05/26/14		FOR APPROVAL		PRINT RECORD		SHOP DRAWING DISCLAIMER	
DATE	APP.	SHOP	FIELD	DIST.	COORD.	F.C.	OFFICE
ALL INFORMATION PROVIDED ON THESE DRAWINGS ARE PREPARED IN ACCORDANCE TO THE CONTRACT DOCUMENTS AND THE SPECIFICATIONS. ALL CLOUDED AREAS SHOW WHERE THERE IS A LACK OF INFORMATION PROVIDED BY THE CONTRACT DOCUMENTS OR SPECIFICATIONS, BUT PREPARED WITH ALL THE INFORMATION AVAILABLE TO US. WE MUST HAVE THESE AREAS ANSWERED BY THE GENERAL CONTRACTOR, ARCHITECT, ENGINEER, BEFORE WE CAN START FABRICATING ANY MATERIAL. PLEASE RESPOND WITH THIS INFORMATION BY MARKING UP OUR SHOP DRAWINGS.							
MATERIAL:	HOLE SIZE:	BOLT GRADE:	MINIMUM WELD:	ELECTRODE:			
A36 UNO	13/16" Ø UNO	A325-N UNO	3/16"	E-70XX			
ARCH:				JOB NAME & LOCATION:			
ENGR:							
CONTR:							
REF:	14-111	JOB:					
DRAWN BY: RR	05/26/14	CHECKED BY: RKB	05/26/14	SHEET: E106

SHEET TITLE: ROOF SECTION & DETAILS - SECTOR A							
MODIFIED DATE: 05/28/14		LAST PLOT DATE: 05/28/14		CAD FILENAME: E106

I SECTION
E103 (REF:-6/ S5.1)

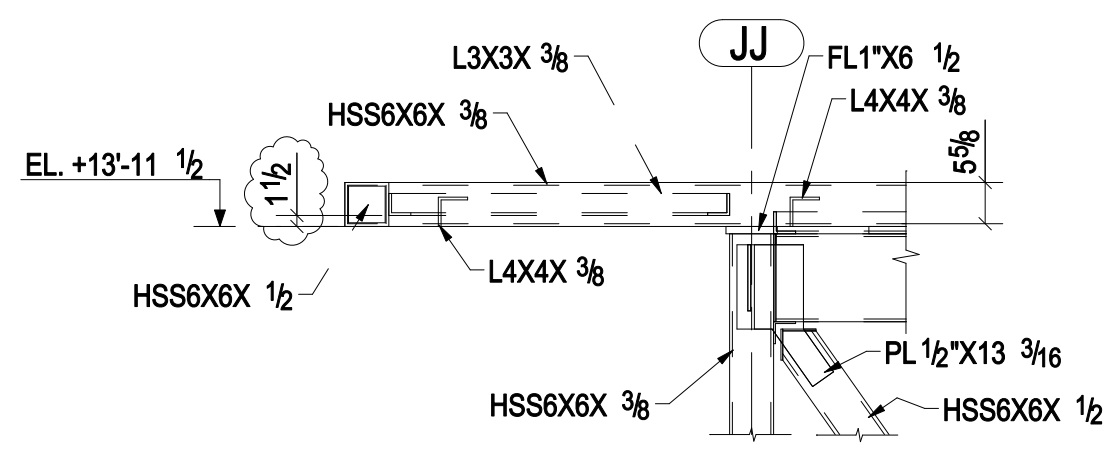
PLEASE VERIFY IF WE NEED TO PROVIDE HSS2" 1/2 X 2" 1/2 X 3/16 BETWEEN JOIST AS PER SECTION A/S3.4.
